Product / Process Change Notification (PCN)	
<input checked="" type="checkbox"/> Major change <input type="checkbox"/> Minor change	
PCN #: PCN_conPSHD_20230727 Affected Series: WE-PSHD -6100xx13321 PCN Date: April 27, 2023 Effective Date: July 27, 2023	Change Category: <input type="checkbox"/> Equipment / Location <input checked="" type="checkbox"/> General Data <input type="checkbox"/> Material <input type="checkbox"/> Process <input type="checkbox"/> Product Design <input type="checkbox"/> Shipping / Packaging <input type="checkbox"/> Supplier <input type="checkbox"/> Software
Contact: Product Management Phone: +49 (0) 7942 - 945 5001 Fax: +49 (0) 7942 - 945 5179 E-Mail: pcn.eican@we-online.com	Data Sheet Change: <input checked="" type="checkbox"/> Yes <input type="checkbox"/> No Attachment: <input type="checkbox"/> Yes <input checked="" type="checkbox"/> No
Description and purpose of change: <p>As a datasheet information amendment, Würth Elektronik will correct the values in the datasheet concerning the product length. This is a datasheet correction only. There will be no change in form, fit, function, quality or reliability of the product.</p>

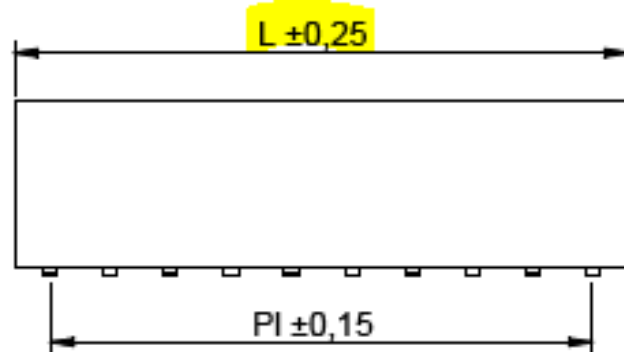
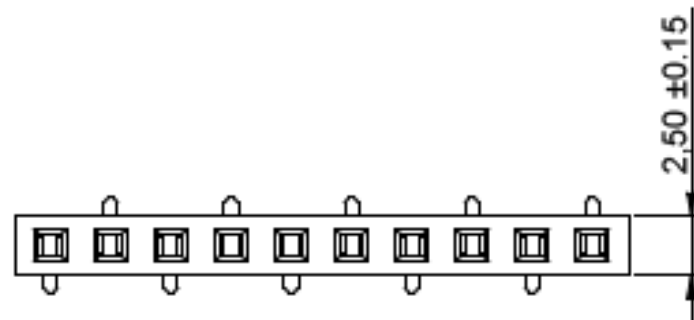
Detail of Change: <p>The Length is incorrect on the datasheet of 6100xx13321 series. 0.50mm will be added to the values of the "Length" field in all the references of the mentioned series.</p>

Reference	L(mm) BEFORE	L (mm) AFTER
61000313321	7.62	8.12
61000413321	10.16	10.66
61000513321	12.7	13.20
61000613321	15.24	15.74
61000713321	17.78	18.28
61000813321	20.32	20.82
61001013321	25.4	25.90
61001113321	27.94	28.44
61001213321	30.48	30.98
61001413321	35.56	36.06
61001613321	40.64	41.14
61002013321	50.8	51.3
61002413321	60.96	61.46
61002813321	71.12	71.62
